Applicants request a Special Exception under Section 2.16.050 K (Carport over a Driveway) in an A-2 (Apartment) zone.

3020 ROY PACE DRIVE

SITE PLAN

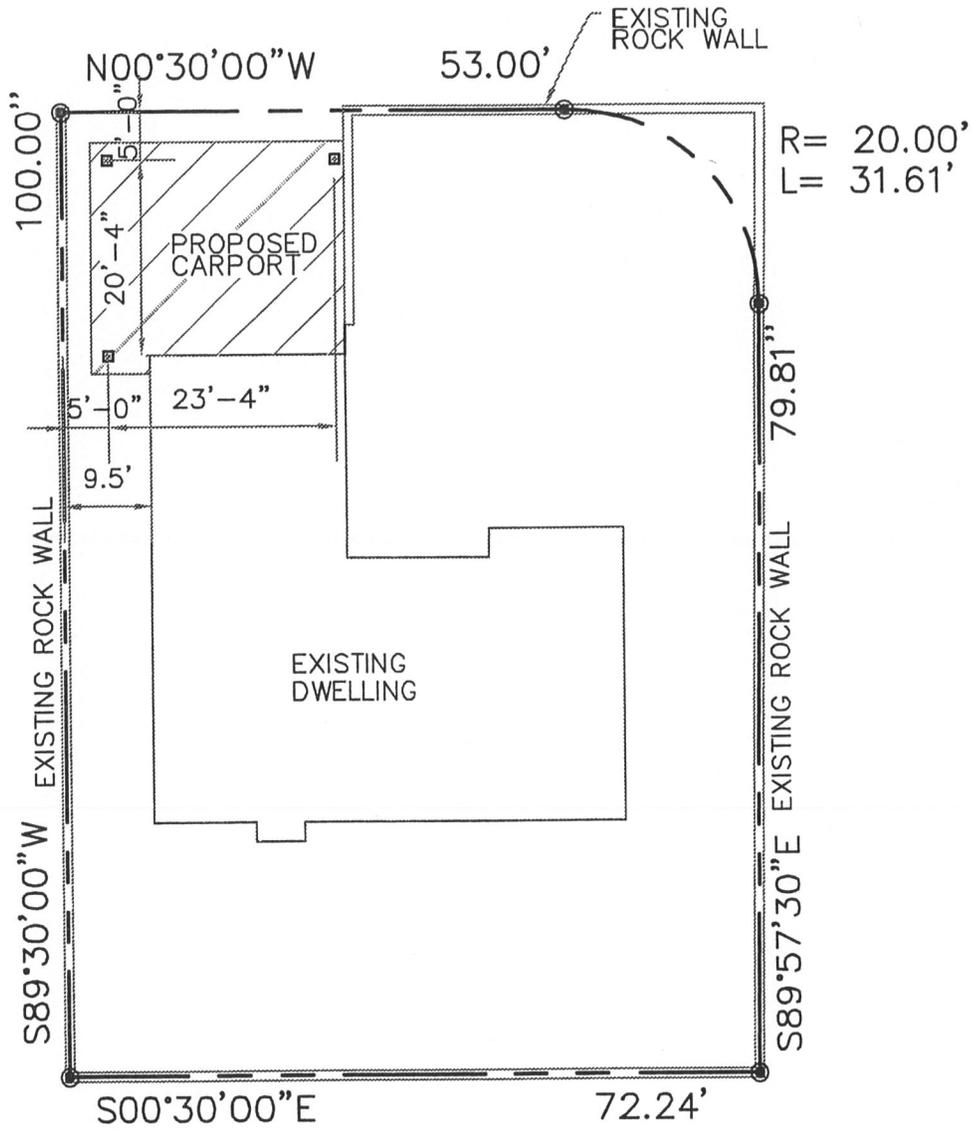
This case was postponed from the November 9, 2009, meeting to the December 14, 2009, meeting. The applicants are requesting the addition of a carport that is proposed to be located to within 5' of the front property line. There are no utility easements at the front property line. The applicant's plans indicate that the materials used for the carport will match the existing house. The roofline of the existing house is noted as 13' on the elevation drawing. The carport roof shall rise no higher than the roof of the house. The Building Permits & Inspection Division has reviewed the structural plans and notes that revisions are necessary. The staff has received one letter in opposition to the request.

Staff notes that the height of the existing wall at the intersection of Roy Pace and Pebble Hills exceeds three feet, and does not comply with Section 20.16.050 (vision clearance at intersections). The applicant shall verify that this wall is on private property, and shall reduce the height of the wall within the twenty-foot vision triangle, or may apply in writing for a waiver on the height from the Traffic Engineer.

Staff is recommending denial as the applicant has not submitted revised structural plans.
